SERVICE BULLETIN

M-1403A

2015 STREET LICENSE PLATE REFLECTOR REGULATORY NON-COMPLIANCE RECALL CODE 0620

Figure 1. Reflector

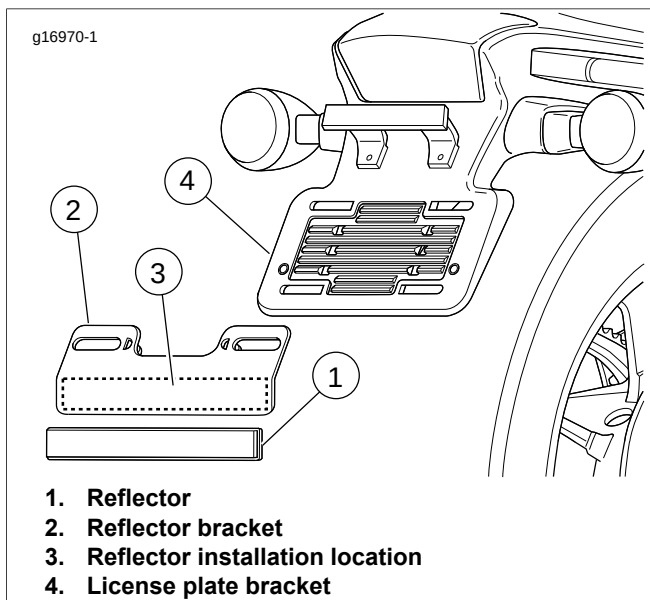
Certain model year 2015 Street family motorcycles built before 3/10/2015 in the Kansas City plant for the North America market (Domestic, California, Mexico and Canada configurations) may have been built without a rear reflector (Part No. 59988-72A). Without this reflector installed, the vehicle does not meet the lighting requirements of FMVSS 108 (U.S.) and CMVSS 108 (CAN). If this reflector is not installed it could reduce the rear conspicuity of the vehicle, possibly increasing the risk of a crash under certain conditions.

1. Verify that the motorcycle is involved in this recall.
2. Remove license plate (if necessary).
3. See Figure 1. Remove adhesive backing from reflector (1). Carefully center and align the reflector with the reflector installation location (3) on reflector bracket (2). Press reflector firmly into place.
4. Install reflector bracket to license plate bracket (4).
5. Install license plate (if necessary).
